# GENERAL ELECTRIC

SUBJECT: SUMMARY OF AUGUST 5, 1980 NRC/GE MEETING ON CORE SPRAY  
DESIGN METHODOLOGY

BWR CORE SPRAY DESIGN

PHOTOS OF DUAL NOZZLE  
TEST ASSEMBLY

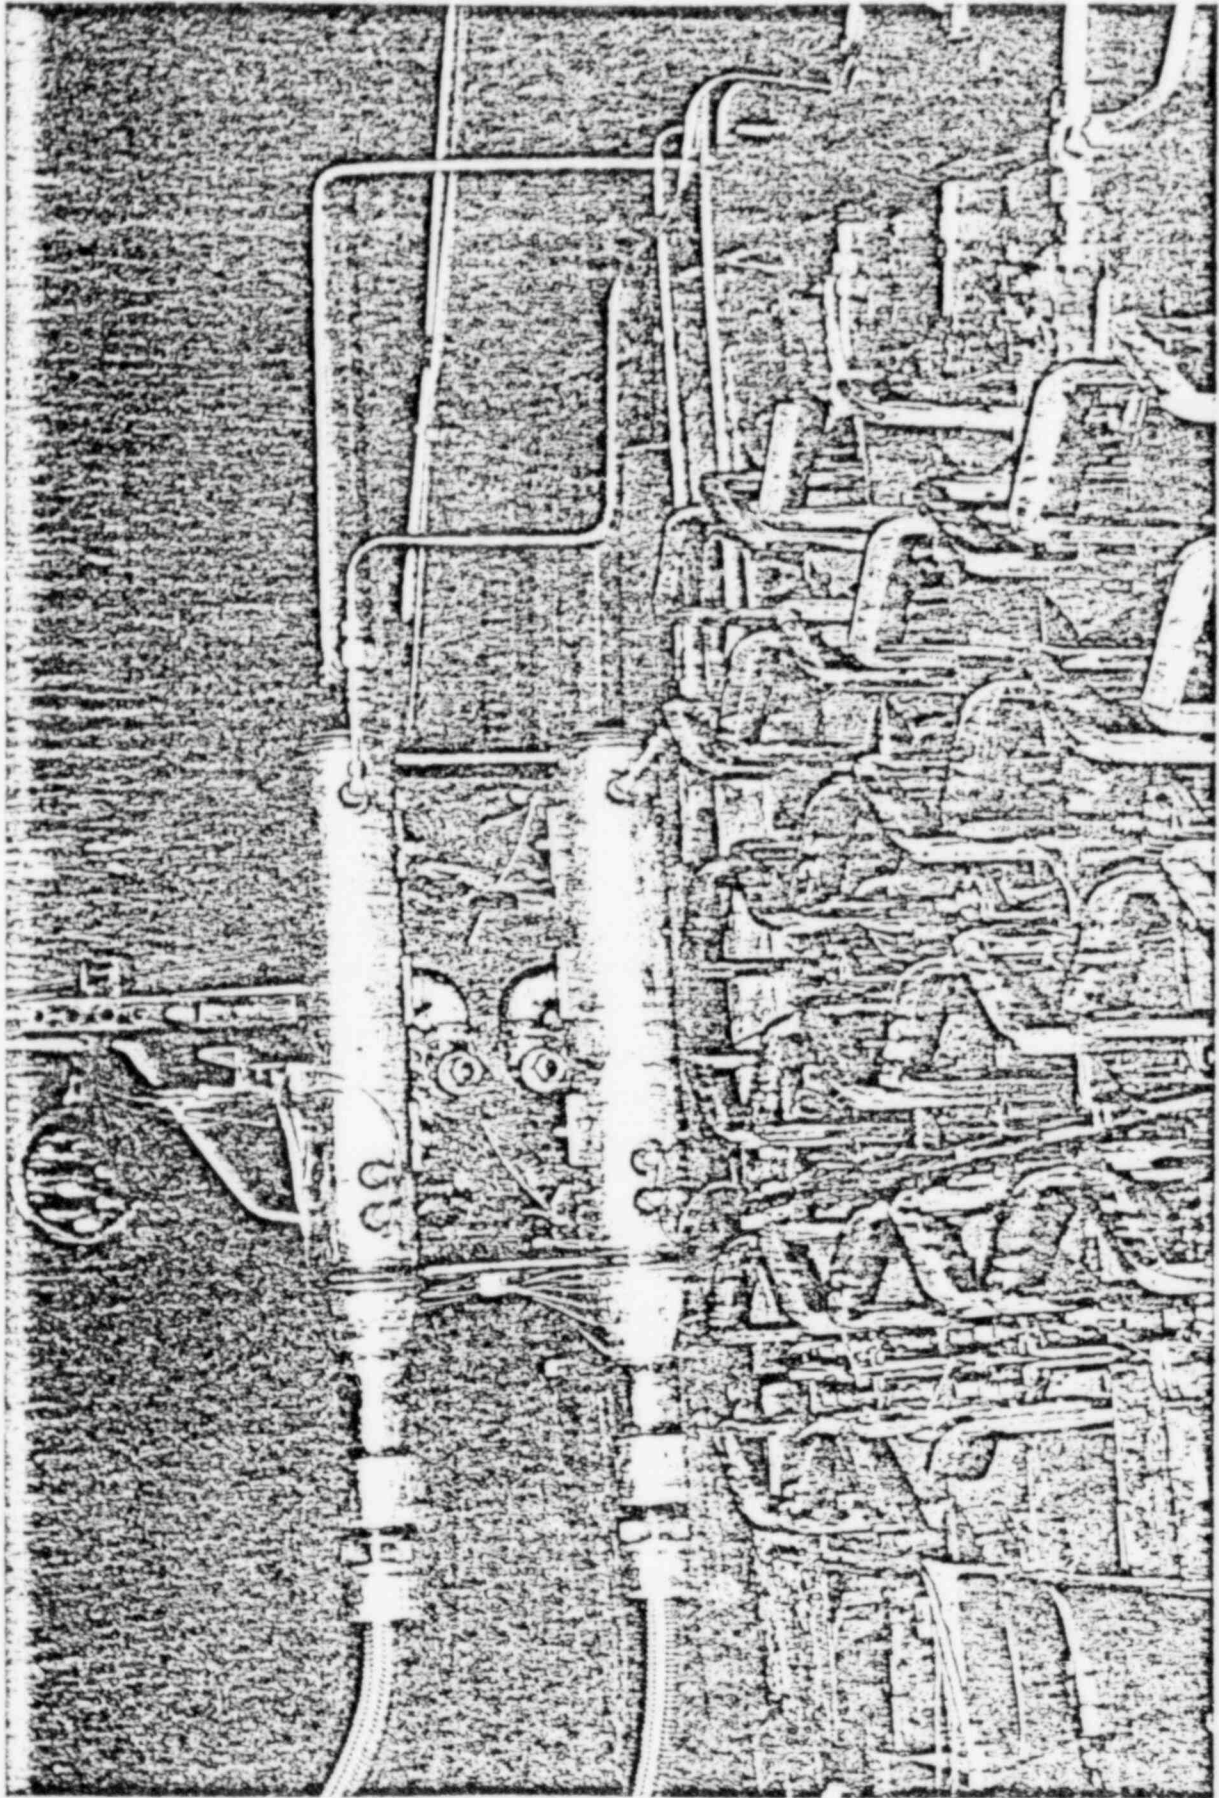
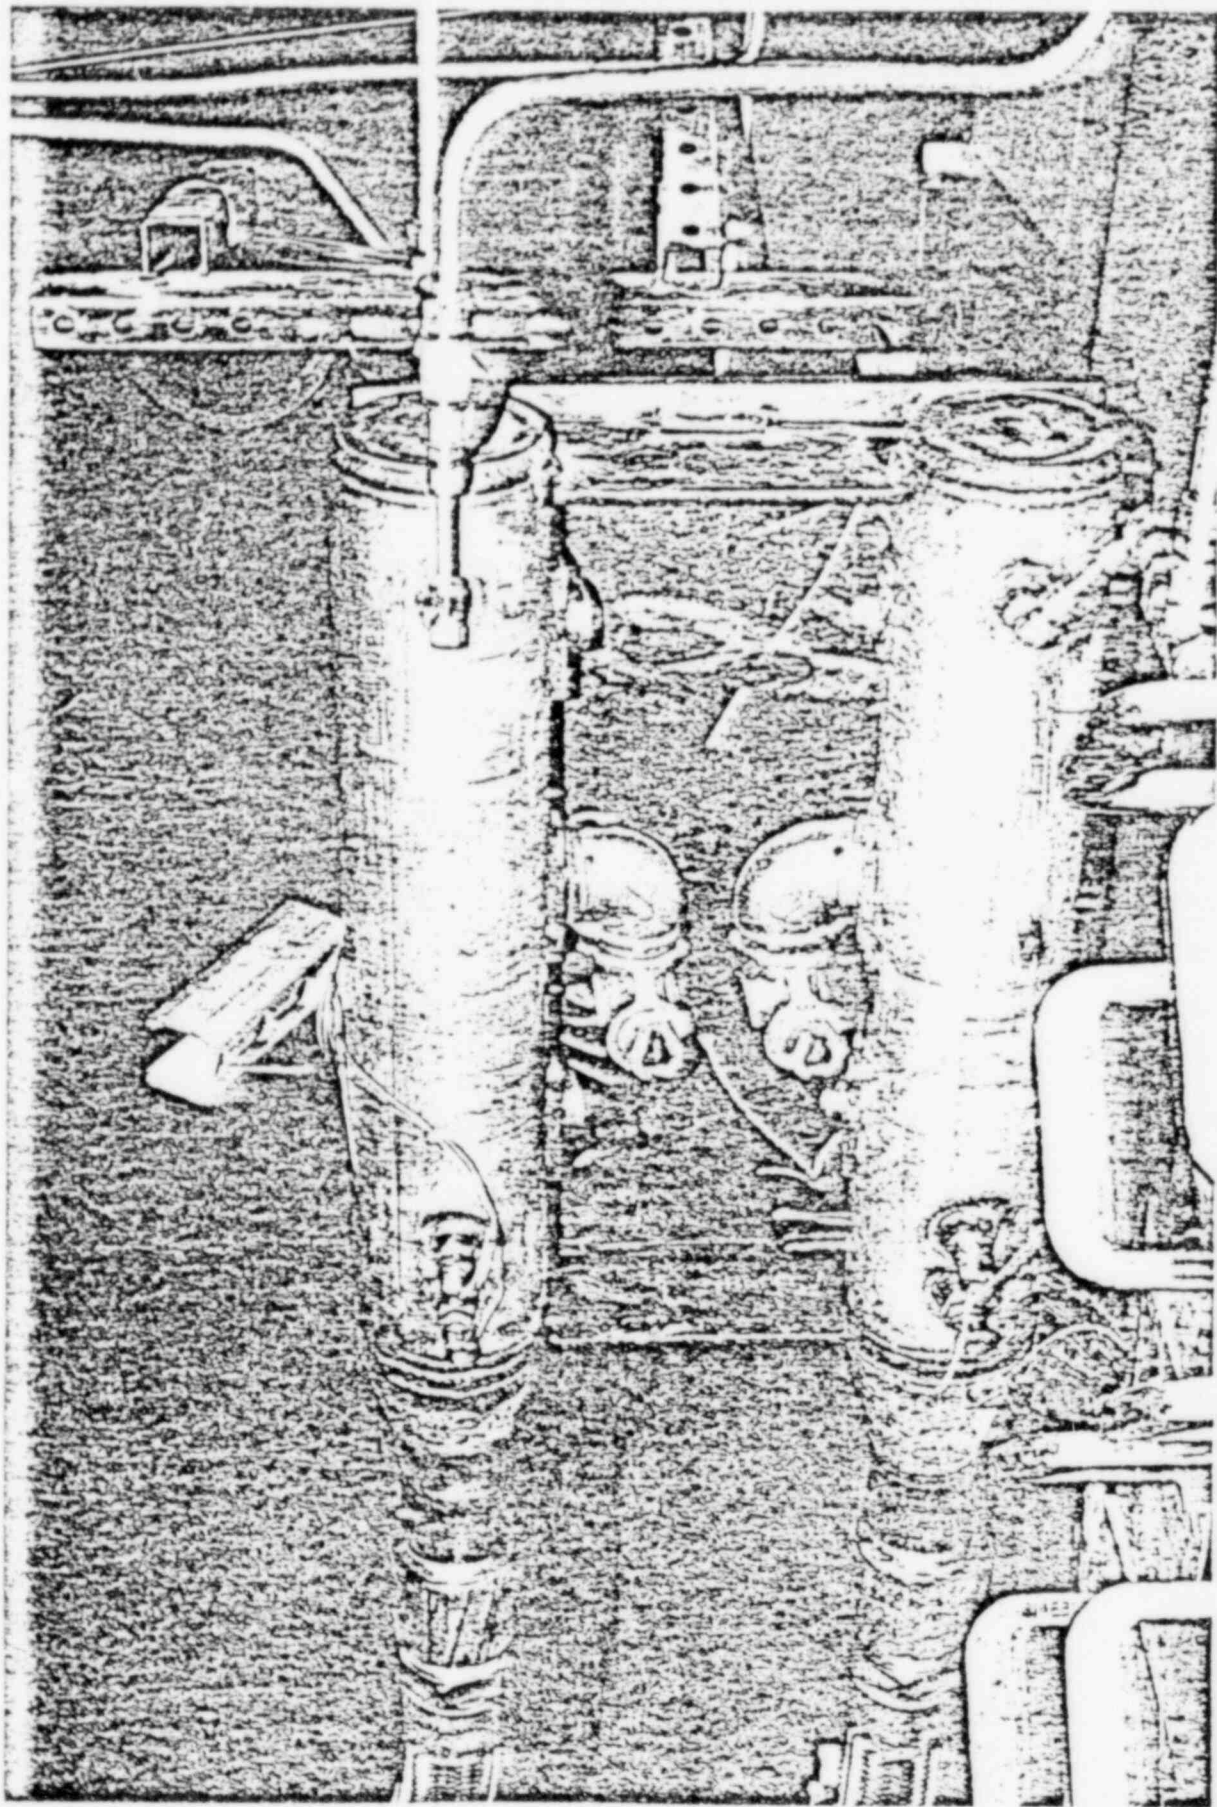
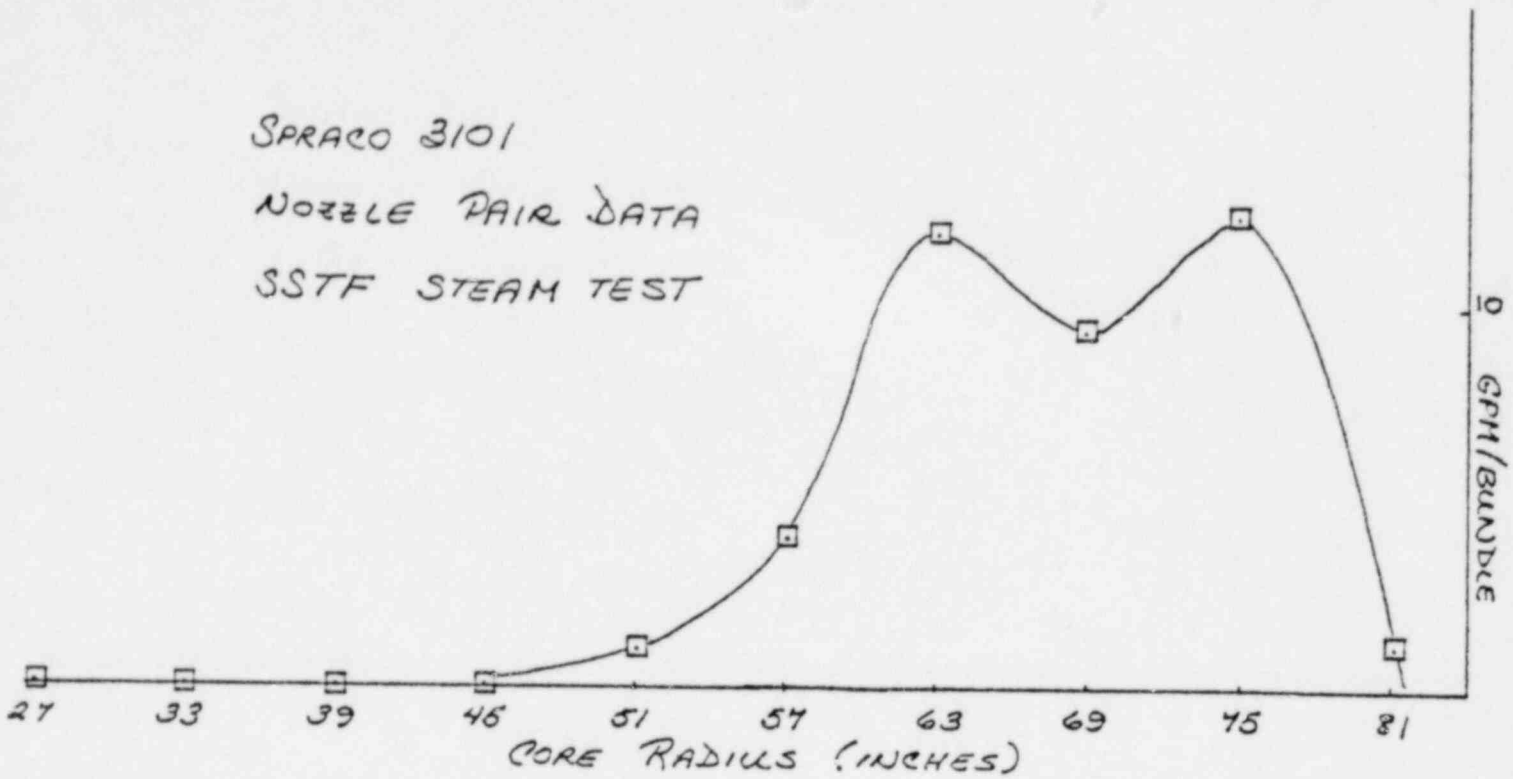
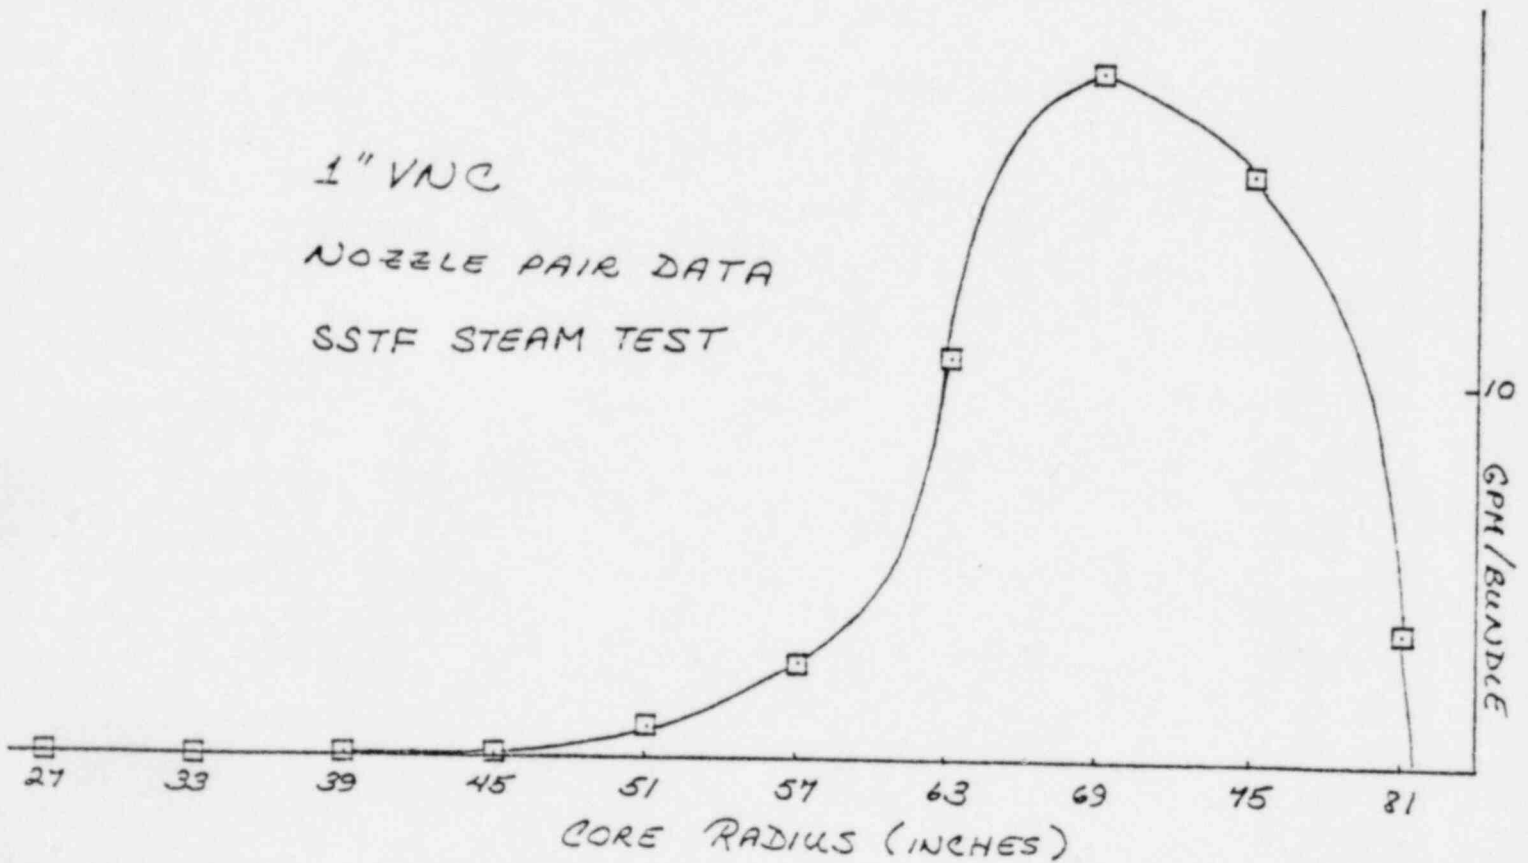
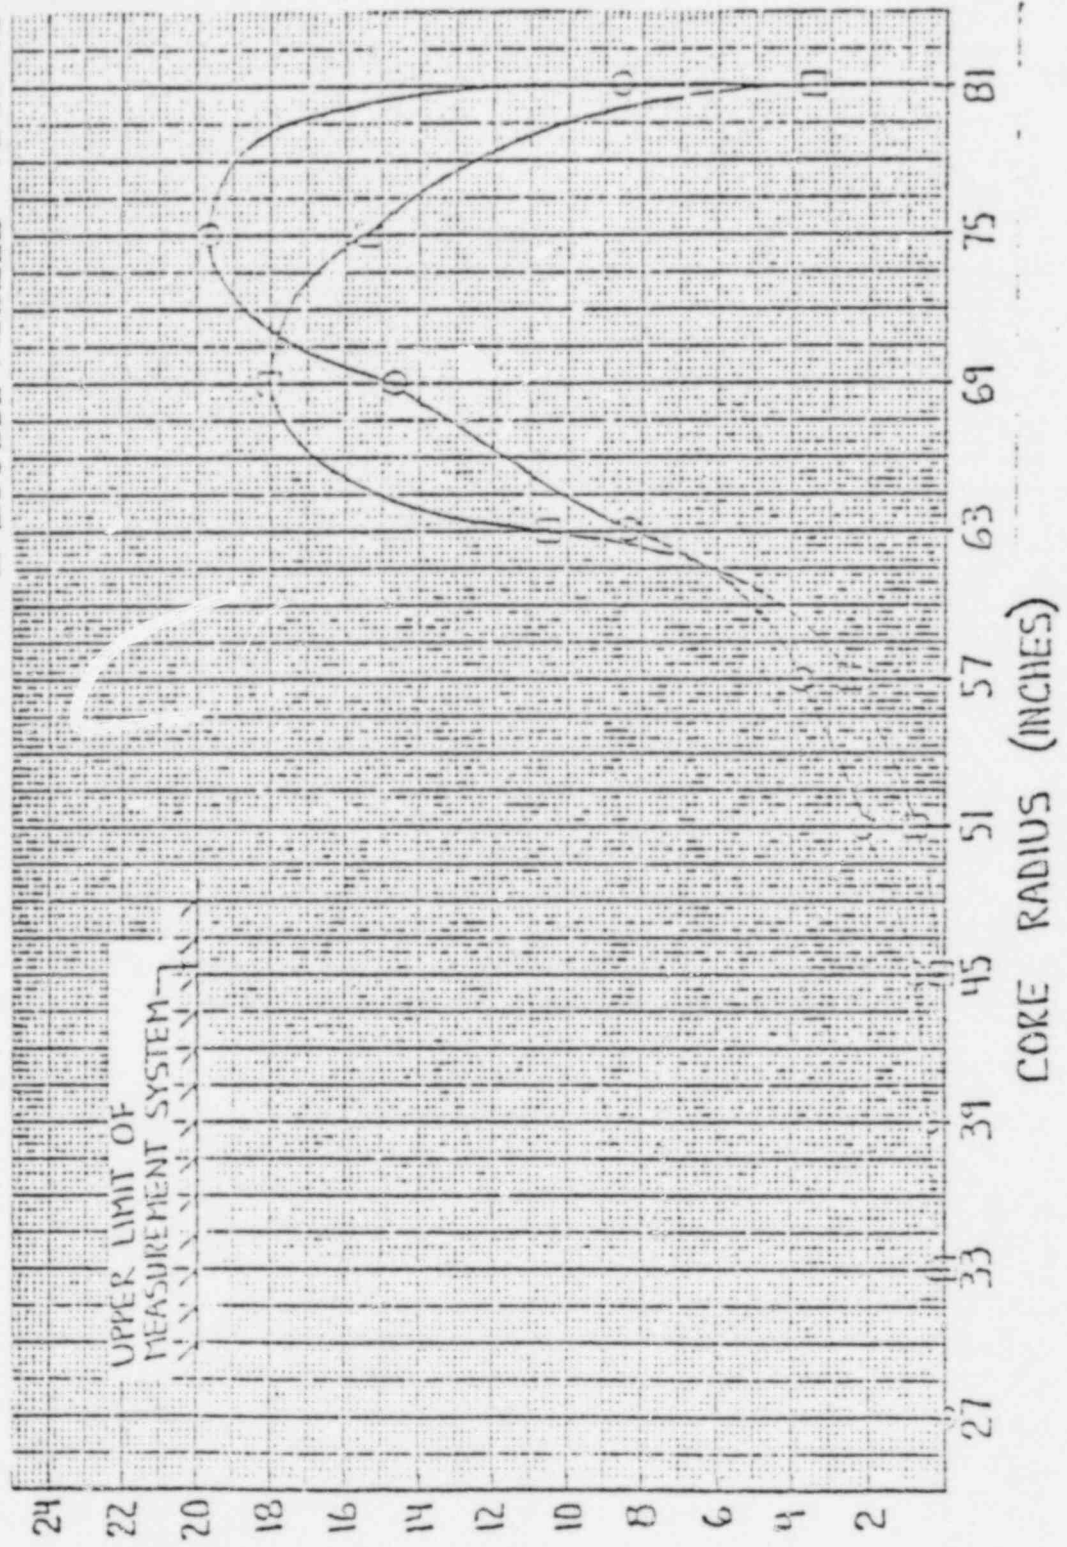
HOW CAN METHODOLOGY BE APPLIED TO BWR/4,5 DOUBLE  
HEADER OPERATION WHEN NOZZLES ARE CLOSE TOGETHER?

WHEN TWO NOZZLES INTERACT IN THE CONDENSING REGION  
CLOSE TO THE NOZZLES, THEY NEED TO BE TESTED TOGETHER IN  
STEAM AND TREATED AS A "SINGLE NOZZLE" FOR THE METHODOLOGY.  
SUCH NOZZLE-PAIR TESTS HAVE BEEN CONDUCTED FOR THE CLOSE VER-  
TICAL-SPACED NOZZLES OF THE BWR/4-5 DOUBLE HEADER. THE RE-  
SULTANT DISTRIBUTIONS SHOW VERY LITTLE EFFECT FROM CONDEN-  
SATION IN THE INTERACTION REGION, AND CONFIRM THAT THE  
METHODOLOGY CAN BE DIRECTLY APPLIED USING THE NOZZLE-PAIR  
APPROACH.

- o APPROPRIATE DESIGN OF SIMULATORS NEEDED
- o TREAT DOUBLE HEADER AS A PSEUDO SINGLE HEADER
- o REST OF METHODOLOGY USED AS FOR BWR/6
